CNL-18-039

Sequoyah Nuclear Plant, Units 1 and 2
Renewed Facility Operating License Nos. DPR-77 and DPR-79
NRC Docket Nos. 50-327 and 50-328

Subject: Tennessee Valley Authority Response to NRC Request for Additional Information related to Sequoyah Nuclear Plant, Units 1 and 2, License Amendment Request to Revise Emergency Plan Staff Augmentation Times (SQN-TS-17-05)

TVA Response to NRC Request for Additional Information

FIGURE B-2
MINIMUM ONSHIFT RESPONSE PERSONNEL

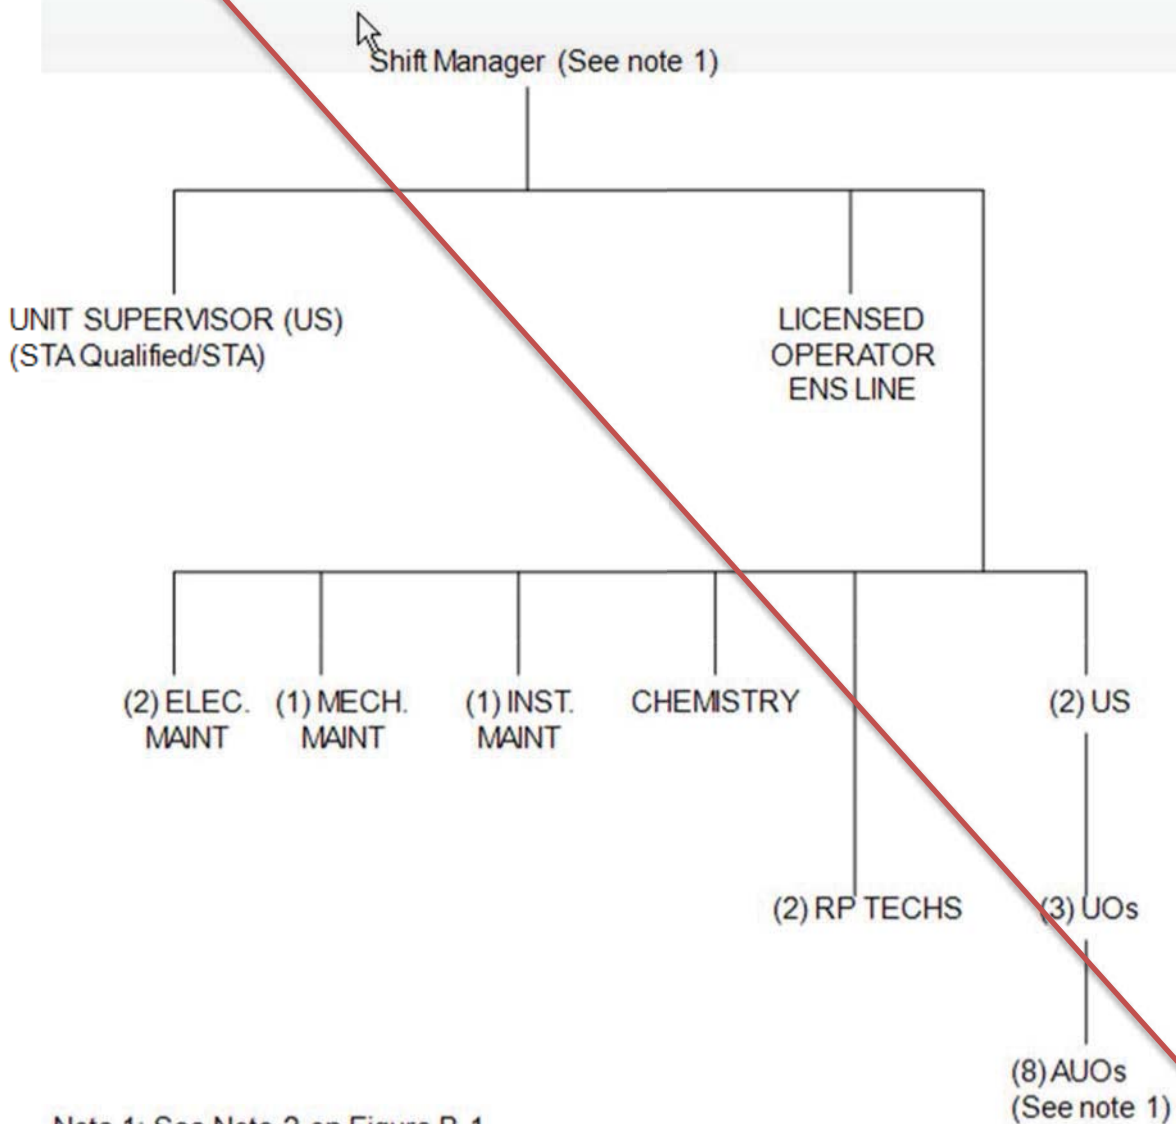
The proposed Figure B-2, "Minimum Onshift Response Personnel, provided in Attachments 1 and 2 of Enclosure 1 to TVA's September 29, 2017 letter, includes the Plant Assessment Manager (PAM) under the Emergency Operations Facility Director major tasks. It appears the PAM provides the CECC Director with information required to perform the protective action and other ERO command and control functions. As such, all senior management positions on Figure B-2 are required to relieve to Shift Manager of ERO responsibilities. Section B.5.1.1 (page B-164) provides the SED will consult with the CECC Director on significant events and their related impacts. It was not apparent what tasks were performed by the fourth senior management position that was included in the current TVA emergency plan. Additionally, it appears the TSC and OSC are activated and the CECC is staffed at an Alert or greater emergency classification.

- c) *Please provide a justification that supports the removal of one senior manager from the current ERO. The justification should explain what function(s) this individual performed and who will perform those functions in the proposed emergency plan.*

TVA is not removing a senior management position from the current ERO. The four positions included in the "SQN Site 60-minute Augmented ERO Table Comparison" of the LAR as providing support for the Emergency Response & Recovery Director (ER&RD) Major Task are the Plant Assessment Manager (PAM), the Emergency Duty Officer (EDO), the TSC SED, and the CECC Director.

All four positions will remain in the proposed ERO. The currently assigned duties for the EDO were found to be more appropriately aligned to the Notification/Communication Major Task area in the proposed Generic REP; the proposed revision reflects this re-alignment. The EDO, as outlined in Section 3.3.6 of the SQN Plan, has responsibility for the verification of initial notifications of TVA and offsite emergency response organizations and is more appropriately assigned to the Notification/Communication Major Task. The EDO is credited as one of the four individuals in the Notification/Communication Major Tasks identified in the "SQN Site 30 Minute Augmented ERO Table Comparison" in the Proposed 60-Minute column, rather than the ER&RD Major Task of that table.

There are no changes in the assigned tasks associated with the relocation of the EDO position in the functional descriptions. Figure B-2 of the SQN Plan is revised to better reflect the role of the EDO.
